LETTER REPORT

Technical Response to the August 20, 2004 Alameda County Health Cares Services

Agency Correspondence Former Val Strough Chevrolet 327 34th Street Oakland, California

CROSS SECTION A-A' SHOWING ANALYTICAL RESULTS FORMER VAL STROUGH CHEVROLET **327 34TH STREET** OAKLAND, CALIFORNIA

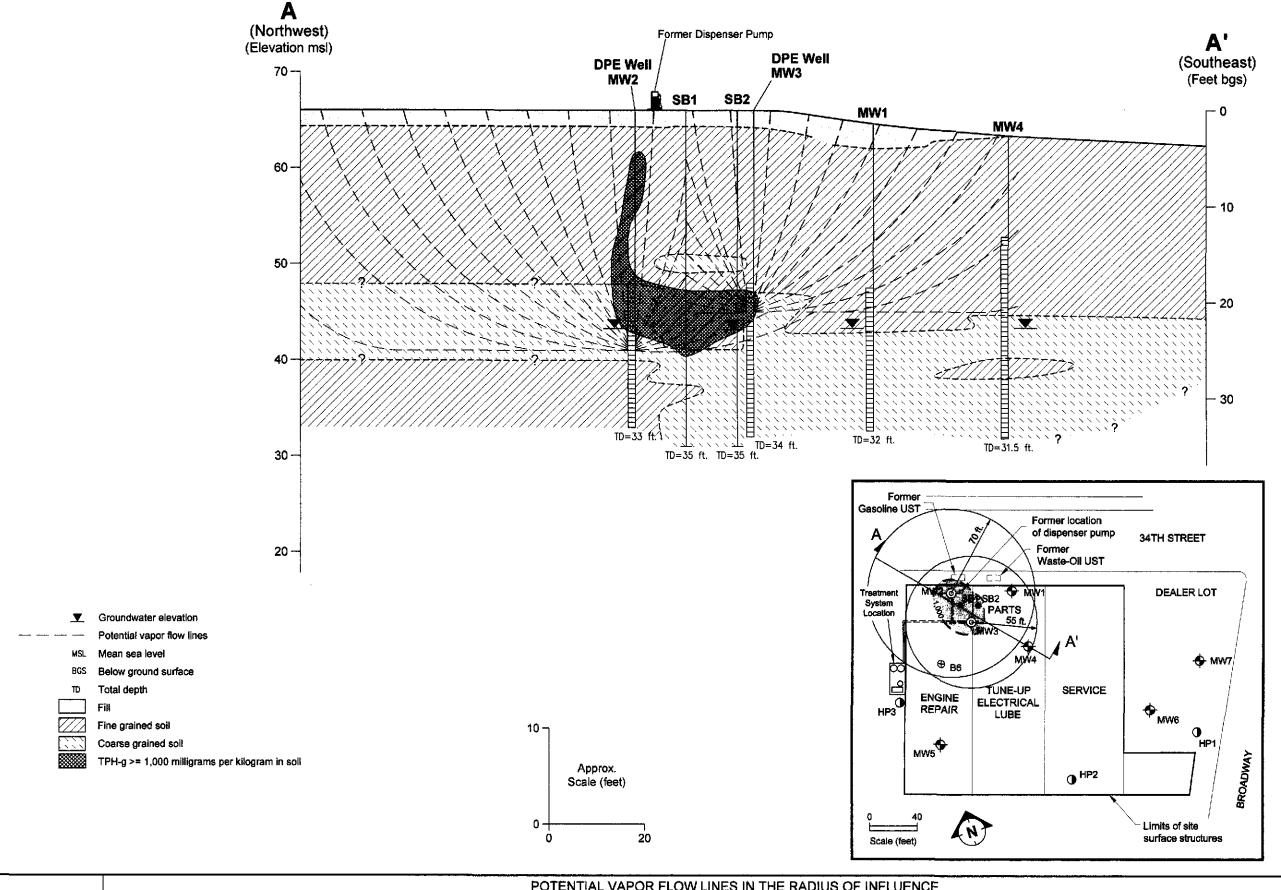
2. Source Characterization - 10,000 mg/kg Total Petroleum Hydrocarbons - Gasoline (TPH-G) and 100 mg/kg benzene were detected in the soil boring at 19.5 to 21 feet below ground surface from MW-2. Thus, the lateral and vertical extent of soil contamination by the adjacent underground storage tank and dispenser needs to be delineated. We request that you propose additional borings to delineate the lateral and vertical extent of soil contamination in the source area. Please propose boring locations in the Work Plan requested below.

3. Soil Contamination above MW-2's Screen — Up to 2,000 mg/kg TPH-G and 7.2 mg/kg benzene were detected in the soil borings above MW-2's screen at 15 feet bgs. The DPE proposed appears to be inadequate to remediate the residual soil contamination in this area. Please submit a proposal to remediate the residual soil contamination in this area in the Work Plan requested below.

Notwithstanding this, the soil data collected during the supplemental site investigation (December 2003) indicate that the lateral and vertical extent of hydrocarbons in the subsurface have been adequately defined. Specifically, soil borings (SB1 and SB2) were advanced to 35 feet bgs in the immediate vicinity of wells MW-2 and MW-3 using a direct push continuous core sampling rig. The results of this investigation were illustrated in schematic geologic cross-sections (see Figure 1), which were previously included in both the SSI/DPE Workplan and the IRAP.

As illustrated on the schematic geologic cross-section included as Figure 1 herein, the vertical extent of soil contamination, and in particular the extent of the historical 10,000 milligrams per kilogram (mg/kg) total petroleum hydrocarbons as gasoline (TPH-g) concentrations at approximately 20 feet bgs in well MW2, has been defined by deeper samples collected in well MW2 (TPH-g = 19 mg/kg at 25 feet bgs) and by deeper samples collected in boring SB1 (TPH-g = 1,100 mg/kg at approximately 22 feet bgs and TPH-g below reporting limits at 35 feet bgs) and boring SB2 (TPH-g below reporting limits at approximately 23 feet bgs).

Similarly, lateral characterization of the hydrocarbon-impacted soil has also been completed based on results of samples from borings SB2, MW3, and MW1 (see analytical results on Figure 1). To the southeast, the extent of hydrocarbon-impacted soil has been defined samples in borings SB2 and MW1 (see Figure 1). Because well MW-2 is located on the upgradient boundary of the property (see plan view inset on Figure 1) and immediately adjacent to the sidewalk and street (34th Street), no additional characterization has been performed farther upgradient and in the street. Such characterization is considered infeasible

As mentioned above, natural attenuation since the primary sources (the underground storage tanks and fuel dispenser) were removed and the referenced sample was analyzed in 1993 have likely reduced hydrocarbon concentrations currently present in soil beneath the site. Shallow soil samples from boring SB1, located within approximately 10 feet of well MW2 did not report similar hydrocarbon concentrations (see Figure 1)
